RESPONSES TO PLANT SPECIFIC QUESTIONS ON DEPRESSURIZATION AND  
DECAY HEAT REMOVAL  
(QUESTIONS 6a, 6b, 12, 13a, 13c and 13d)

SAN ONOFRE NUCLEAR GENERATING STATION  
UNITS 2 AND 3

JUNE 1983

**TUBE WALL THINNING  
ACCEPTANCE CRITERIA**

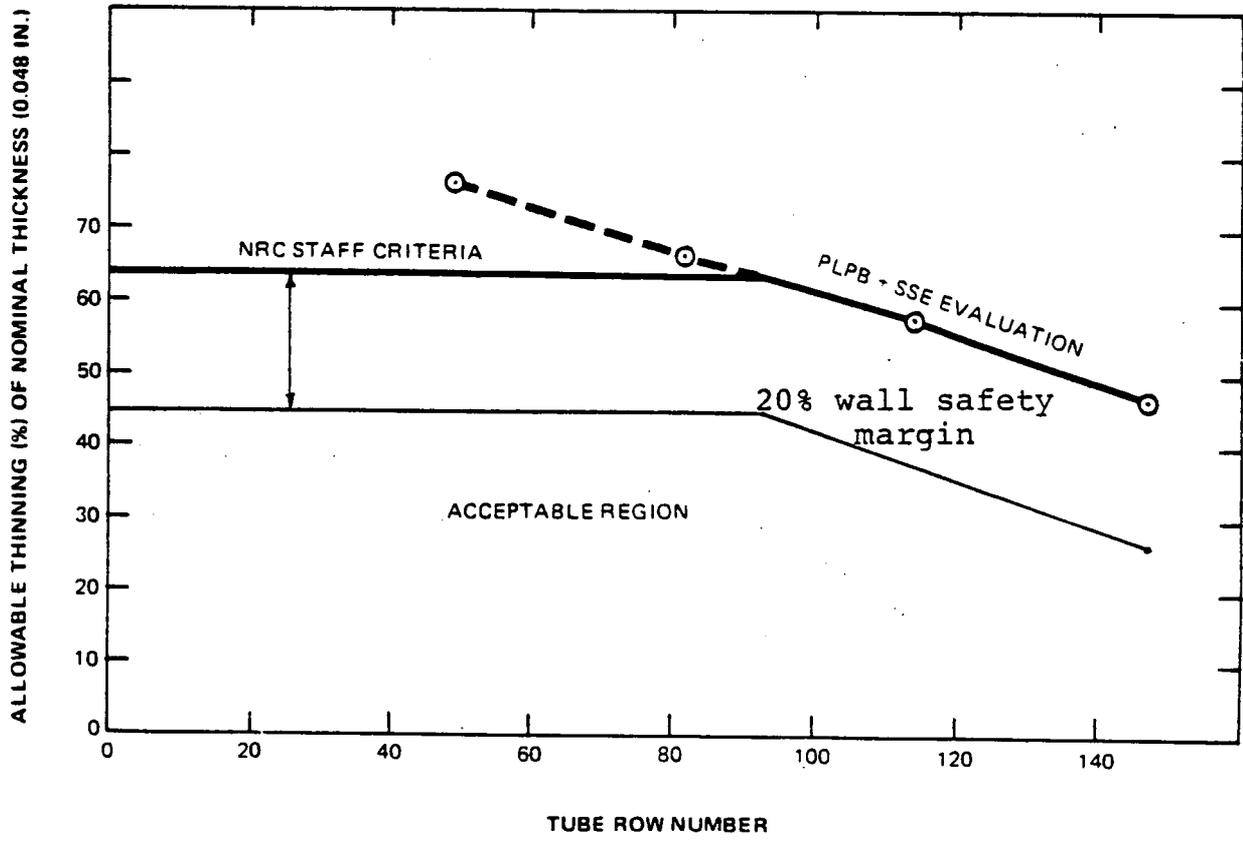
- a. What is the minimum allowable wall thinning that could exist in the steam generator tubes without plugging?

- c. Given a steam generator with the maximum allowed tube thinning and degradation, confirm that those tubes will maintain their integrity by demonstrating they have been analyzed and shown to

When evaluating against the above criteria for San Onofre steam generator geometry and operating conditions, an allowable tube thinning as shown in the upper curve of Figure 1 is permissible. However, the technical specification is conservatively set at a 20% lower tube wall thinning value.

In summary, the design basis can be met for a design base earthquake in conjunction with either a primary loop pipe break (PLPB) or a main steam line break (MSLB), with appreciable tube wall thinning. The actual allowable thinning being related to tube row can be as high as 64% wall penetration for rows 1-91 and decreasing linearly to 47% wall penetration at row 147. If it is determined during surveillance testing that tube wall thinning may approach 20% of the value shown in Figure 1 during the next operating cycle, the tubes will be removed from service by plugging to ensure that the thinning criteria will not be violated.

**Figure 1**  
**SIMPLIFIED SCHEMATIC OF SONGS 2 AND 3**  
**ALTERNATE SECONDARY HEAT REMOVAL CONFIGURATION**

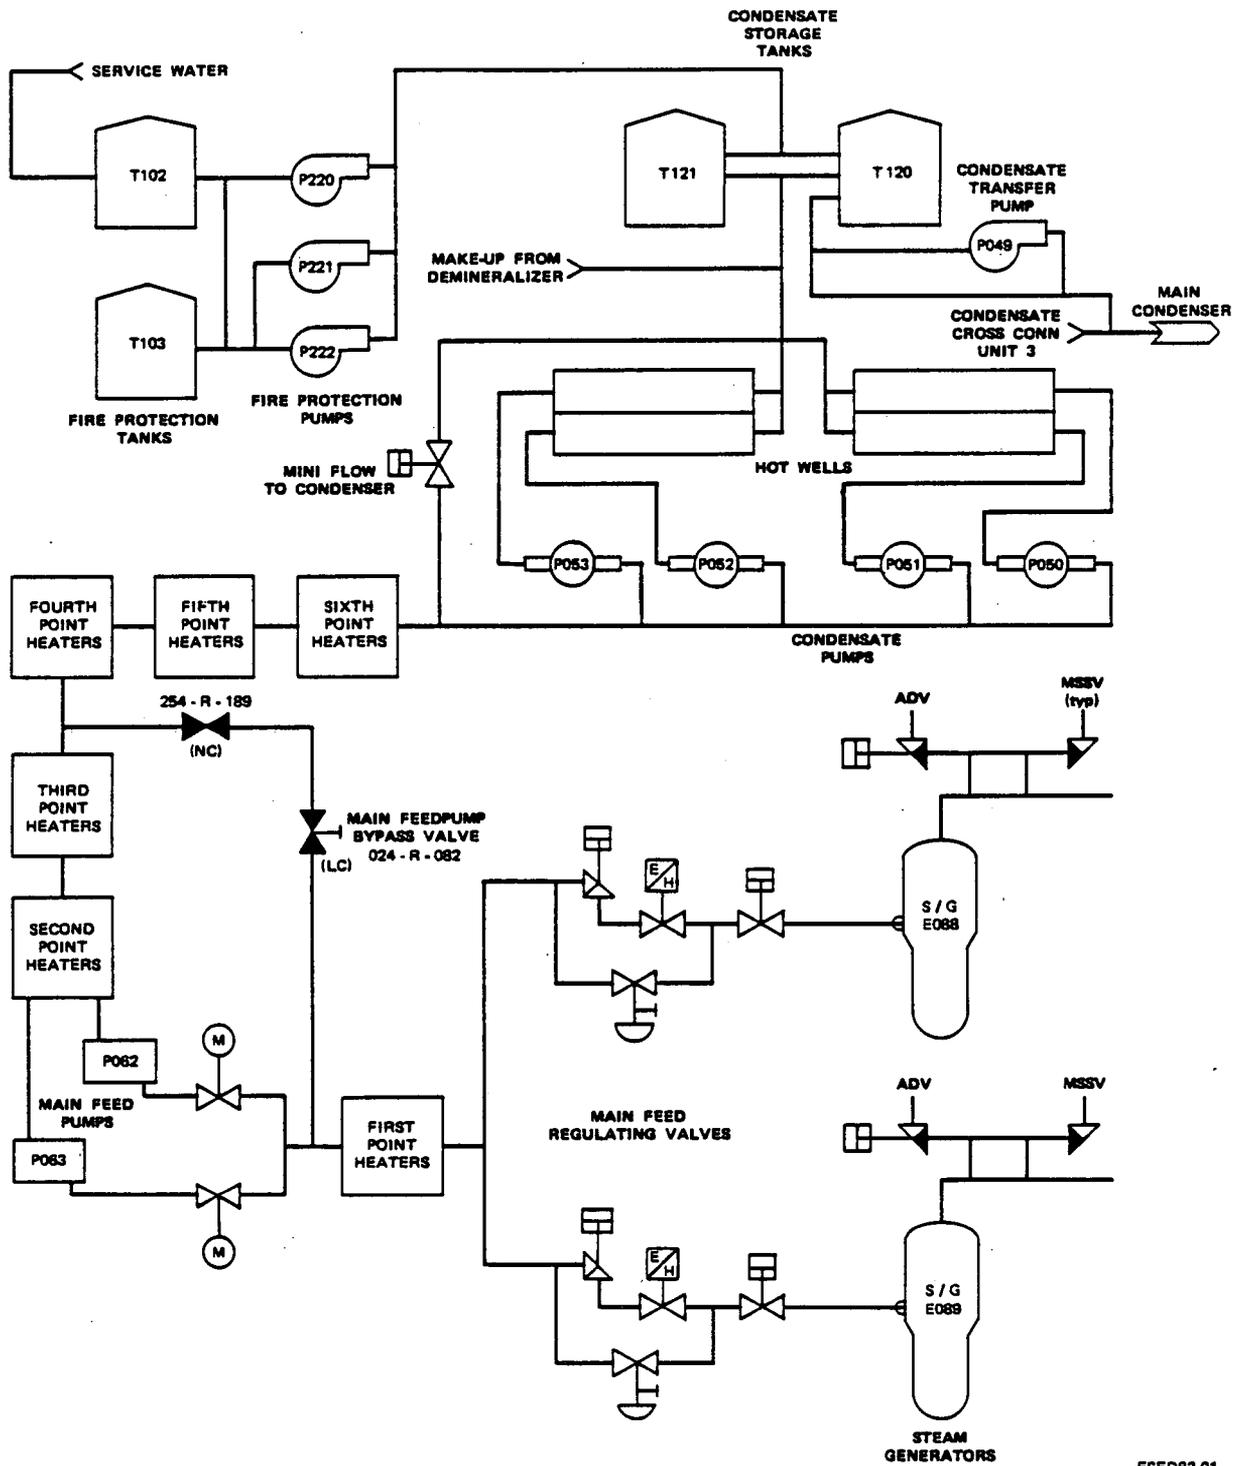
Describe the proposed low pressure system to supplement the AFWS and its use, including water supplies (and their capacity), flow paths, pumps, power supplies to components, control equipment and procedures.

In the unlikely event of a loss of the safety grade three train AFWS at SONGS 2 & 3, there are several sources of low pressure water available for use as makeup to the steam generators (see Figure 1). The preferred source would be the condensate system of the affected unit. The four condensate pumps are relatively high head (500-600 PSIG) and can use water from multiple sources (e.g., hotwell, condensate storage tanks, demineralizer make up) and through use of the feed pump bypass line, deliver make-up directly to each steam generator. Each condensate pump has a capacity of 7750 GPM. The normal condensate make-up sources (hotwell and condensate storage tanks) contain 746,600 gallons. If additional make up is required, there are several alternate means to refill the condensate storage tanks. Make up grade water is available from the condensate system of the companion unit through the condensate cross tie line and from the onsite demineralizer system. As a back up to these sources, service grade water is available from the fire protection system of Units 2 & 3 as well as Unit 1. The fire protection reserve for Units 2 & 3 is 750,000 gallons and Unit 1 has a 3 million gallon reservoir.\* This means that there is over 5 million gallons of on-site condensate make up water for the SONGS 2 & 3 steam generators to supplement the AFWS. There is also a virtually unlimited supply of potable water available from the domestic water system (Tri-Cities Municipal Water District).

The Appendix to Question 6a's response contains a detailed procedure guideline for setting up the condensate system to use the above sources of water and pumps. Table 1 lists the available sources and quantity of water including pump power supplies, power requirements and flow rates.

In summary, the AFWS at SONGS 2 & 3 can be supplemented by the condensate system for steam generator make up in the following ways:

CONCEPTUAL SONGS 2 AND 3 PORV SYSTEM

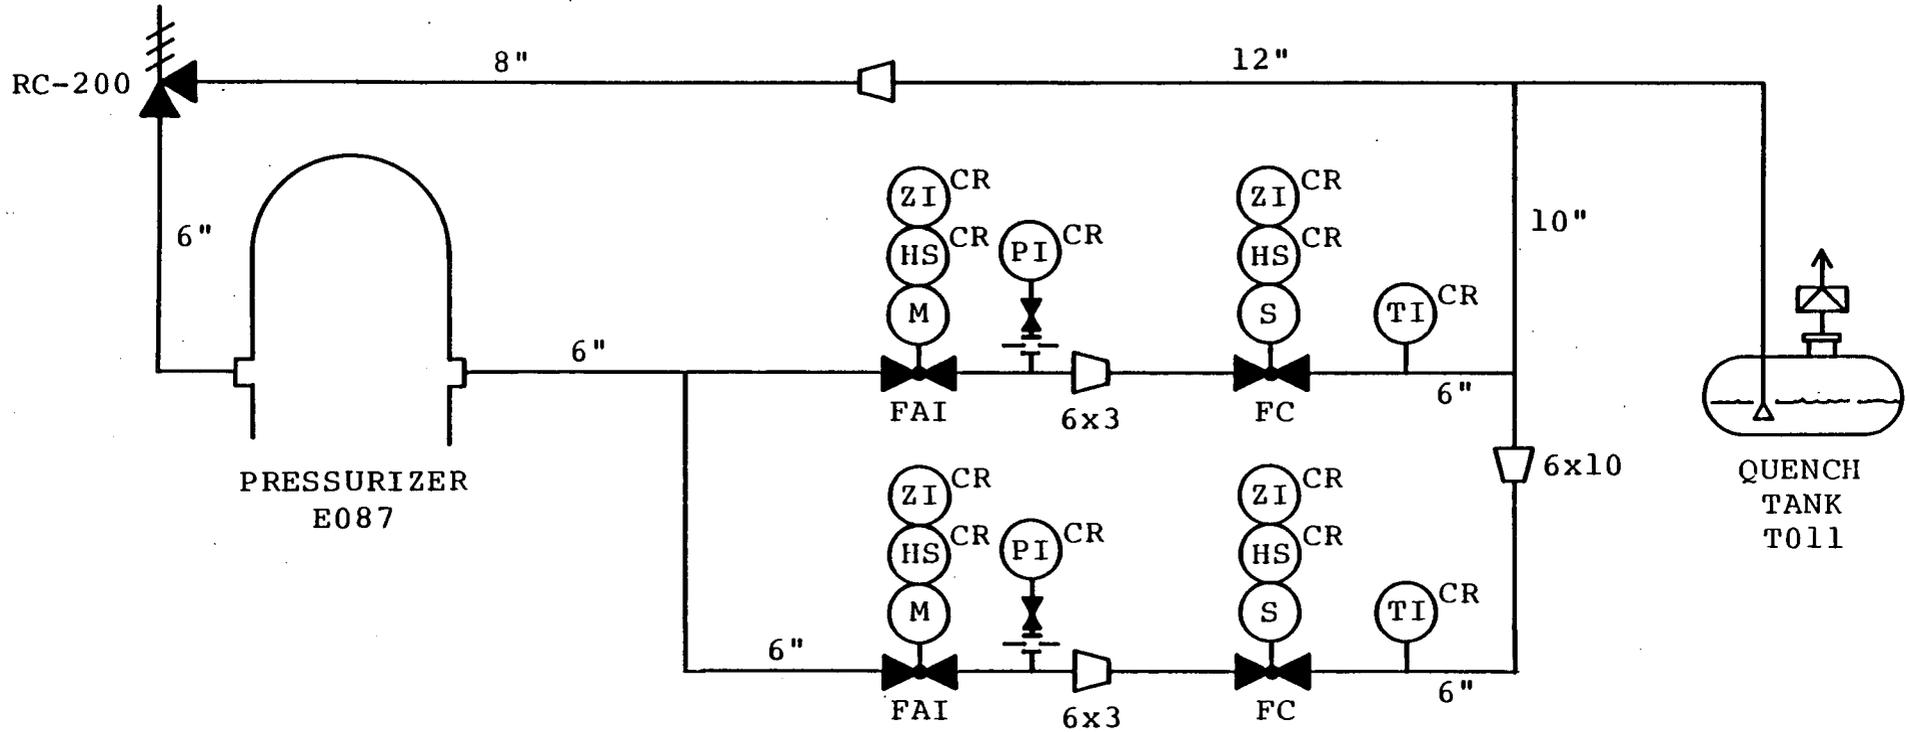
If the results of the risk analysis (Question 11) yield appreciable gain in safety, what could be the cost in-stalling PORVs?

The PORVs could be used as a backup depressurization and decay heat removal system to be operated manually in the event that multiple failures preclude use of safety grade systems (e.g., auxiliary feedwater, auxiliary spray systems). The PORVs, if required, could be installed on an existing spare pressurizer nozzle and connected to the existing pressurizer quench tank. Figure 1 is a schematic of the design used for the SONGS 2 and 3 PORV cost estimate.

This cost estimate is based on the design shown in Figure 1 and is in 1983 dollars. The estimates are for costs associated with engineering design and services, procurement of hardware, and installation labor. It does not address factors such as the cost of money (i.e., finance charges), or costs associated with postponing other projects to complete the PORV installation.

TUBE WALL THINNING  
ACCEPTANCE CRITERIA

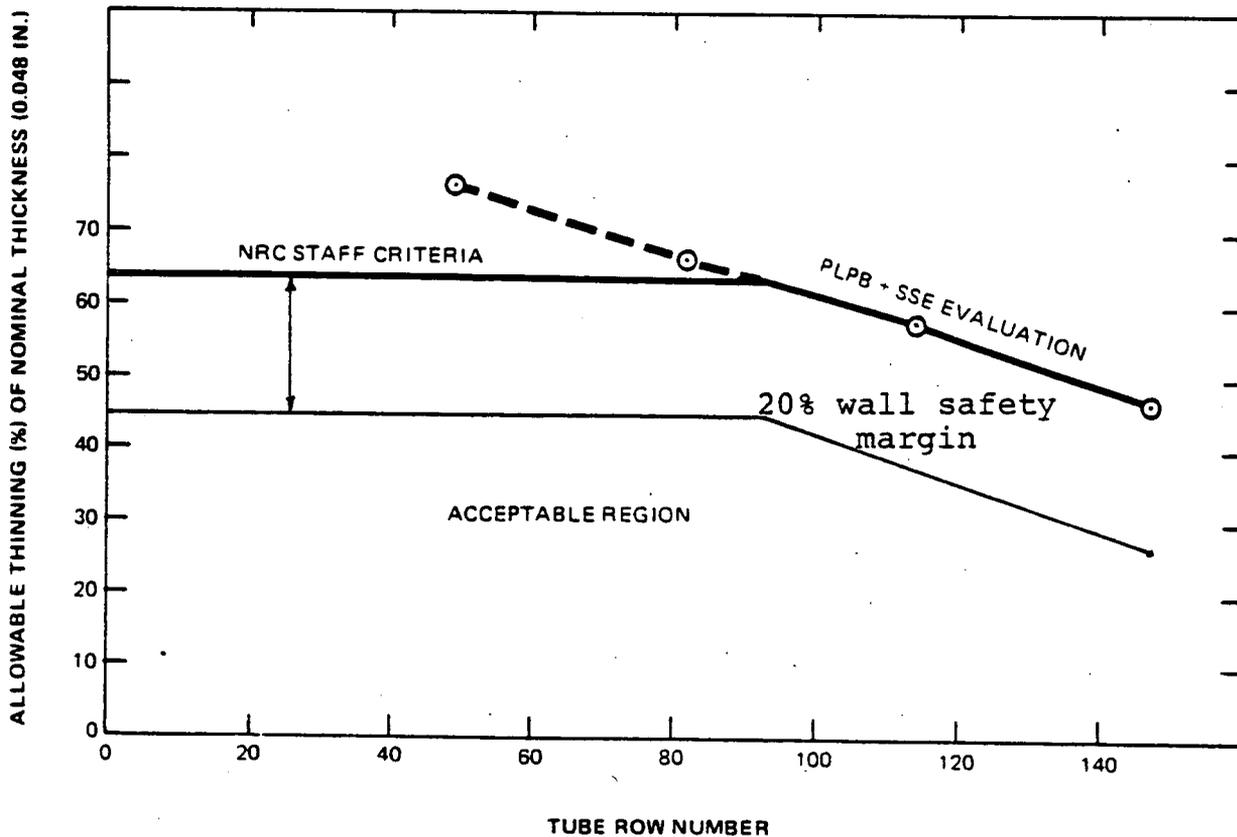
- a. What is the minimum allowable wall thinning that could exist in the steam generator tubes without plugging?
- c. Given a steam generator with the maximum allowed tube thinning and degradation, confirm that those tubes will maintain their integrity by demonstrating they have been analyzed and shown to remain intact for all design basis loadings used for the steam generator design including seismic loads.
- d. Describe the analytical and experimental justification for establishing a minimum acceptable steam generator tube wall thickness for the CE System 80 steam generators in accordance with guidelines in Regulatory Guide 1.121. "Bases for Plugging Degraded PWR Steam Generator Tubes". The justification should include the analyses to calculate the hydraulically induced loading on the steam generator and the thermal response of its tubes and shell to an assumed LOCA, MSLB and an FWLB.

As the horizontal tube spans become longer (i.e., higher number rows with larger radius of curvature), the loads and hence stresses, become greater in spite of the increased number of tube supports. These results were found to be controlling with regard to allowable tube thinning for tube rows 92 through 147. Figure 1 shows the curve for acceptable tube wall degradation using absolute NRC criteria in addition to a curve utilizing a 20% safety factor to account for flaw detectability and degradation between inspections.

When evaluating against the above criteria for San Onofre steam generator geometry and operating conditions, an allowable tube thinning as shown in the upper curve of Figure 1 is permissible. However, the technical specification is conservatively set at 20% lower tube wall thinning value.

In summary, the design basis can be met for a DBE in conjunction with either a PLPB or MSLB, with appreciable tube wall thinning. The actual allowable thinning being related to tube row can be as high as 64% wall penetration for rows 1-91 and decreasing

linearly to 47% wall penetration at row 147. As an additional safety factor, if it is determined during surveillance testing tube wall thinning may approach 20% of the value shown in Figure 1 prior to the next operation cycle, the tubes will be removed from service by plugging.
